From: Matta, Samir <SFMatta@lan-inc.com>
Sent: Thursday, April 03, 2014 3:57 PM
To: Prysby, Mike (DEQ)
Cc: Busch, Stephen (DEQ)
Subject: Re: Flint WTP - Bray Road Lagoon Proposal - MDEQ comments

From: Prysby, Mike (DEQ)
Sent: Thursday, April 03, 2014 9:57 AM
To: sfmatta@lan-inc.com
Cc: Busch, Stephen (DEQ)
Subject: Flint WTP - Bray Road Lagoon Proposal - MDEQ comments
Attachments: Pre-lim Eng Reports - DEQ Comments III April 2, 2014.doc

**Flint WTP Improvements
Phase II
Segments I-III
MDEQ Comments
April 3, 2014**

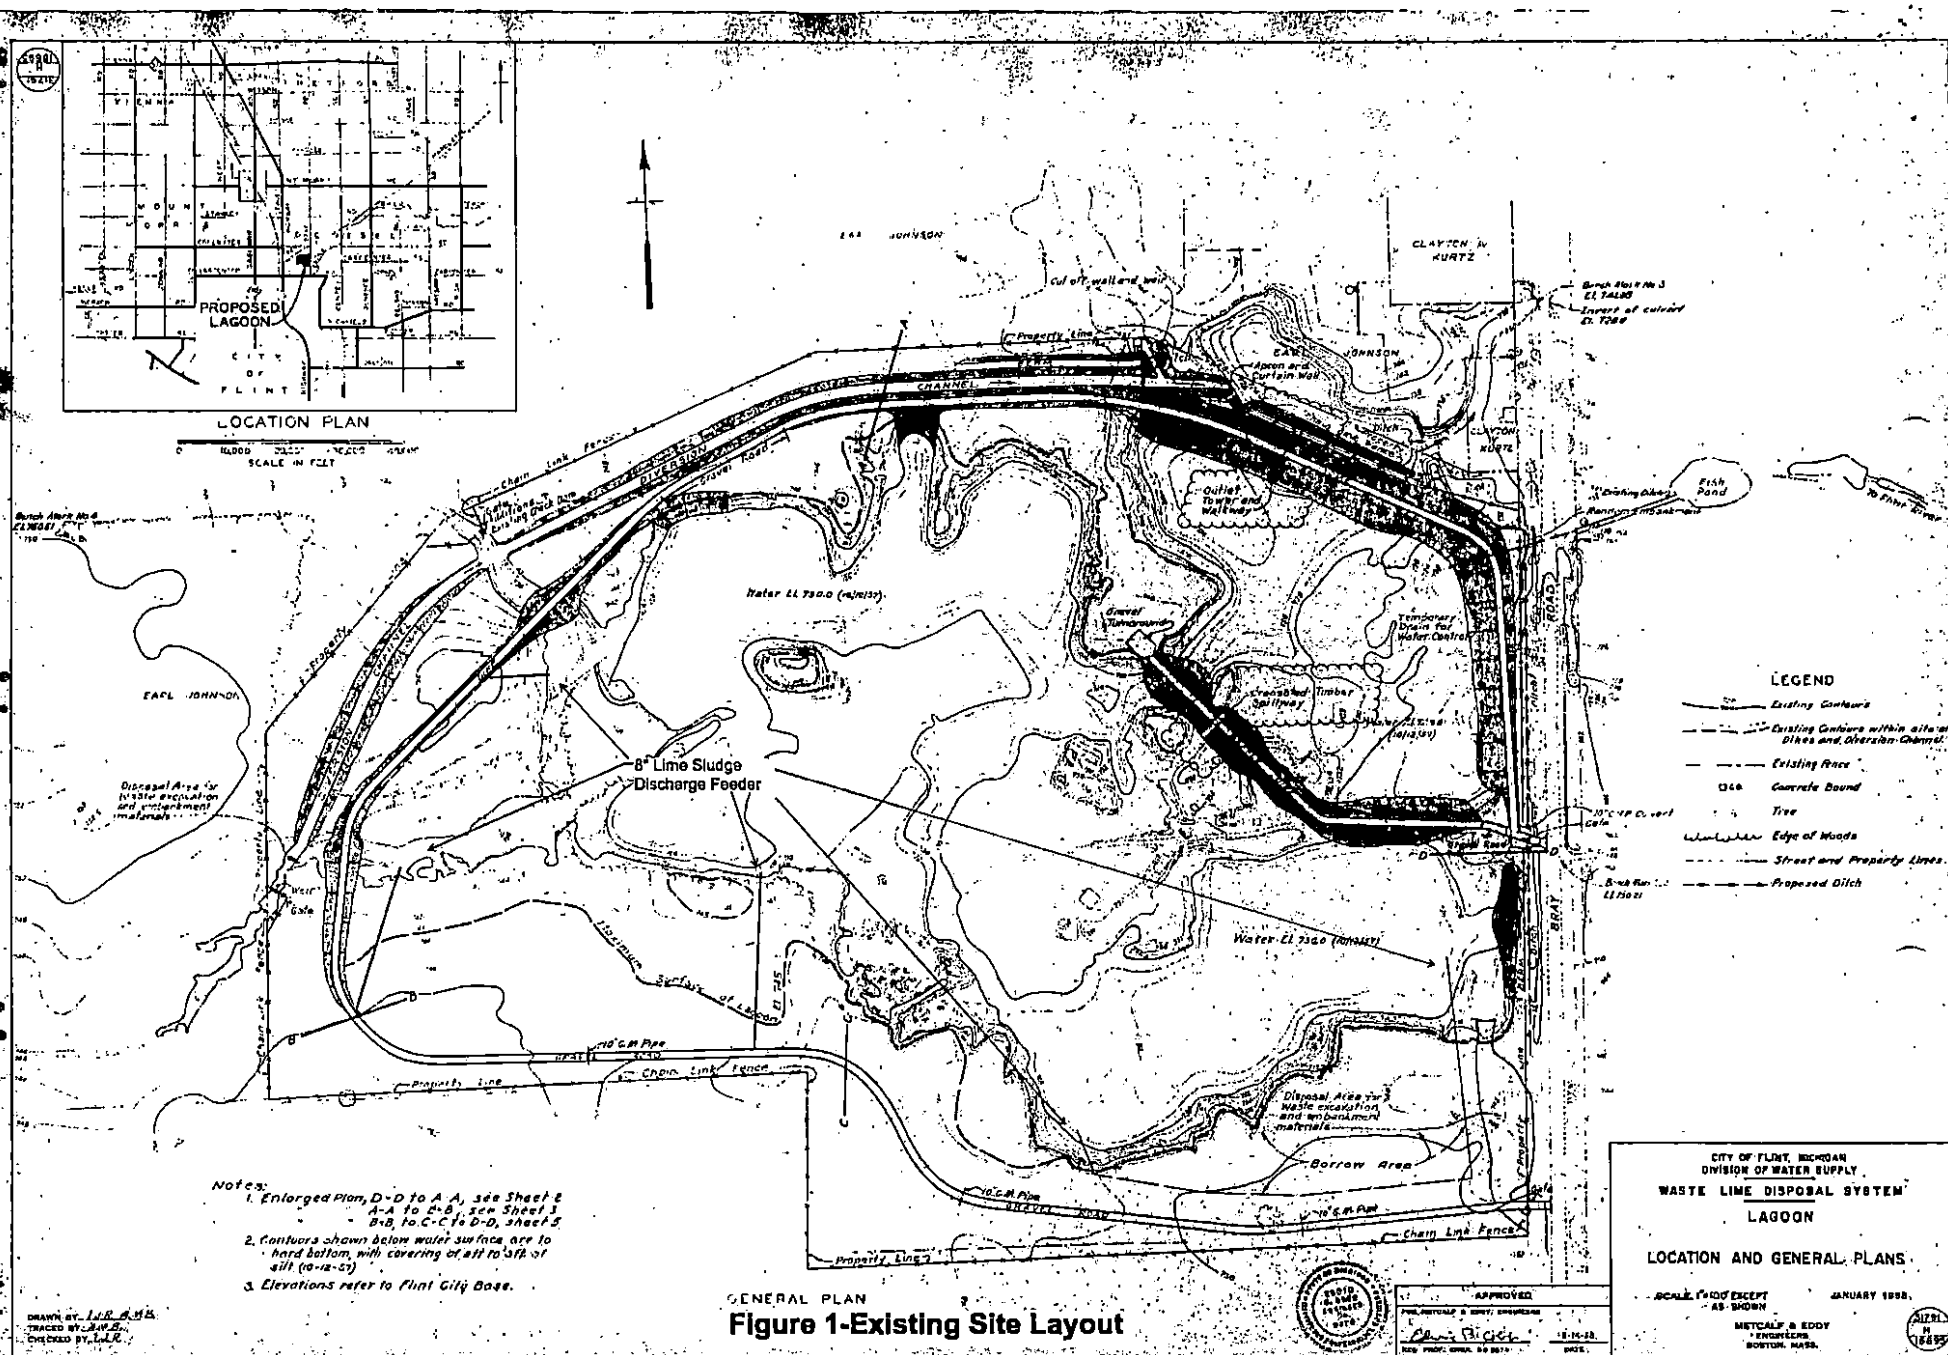
1. Evaluate the existing conditions in comparison to the original site design and its intended functionality in order to evaluate required design changes. Figures 1 & 2 highlight the original design and select key elements while Figure 3 shows the changes that may affect proper operation of the system.
2. Site survey of the project site has been completed. Collected data confirms the plan that the site has the required capacity to handle the continuous full time operation of the plant during the next 30 to 36 months until the KWA system is constructed and connection is made at which time, lime softening will not be required. Figure 4 highlights the current

4. A separation barrier will be constructed to isolate the disposal area from the lime sludge discharge bay as shown in Figure 4.
5. A decant structure and submersible pump station will be constructed in the SE corner of the upper lagoon bay to treat and dispose of flows into the City's sanitary system. This system will be fully operational while the plant is treating river water and lime softening is required. A new storm treatment outlet structure may be reestablished with the approval of MDEQ after the KWA connection is online and lime softening is no longer in use.
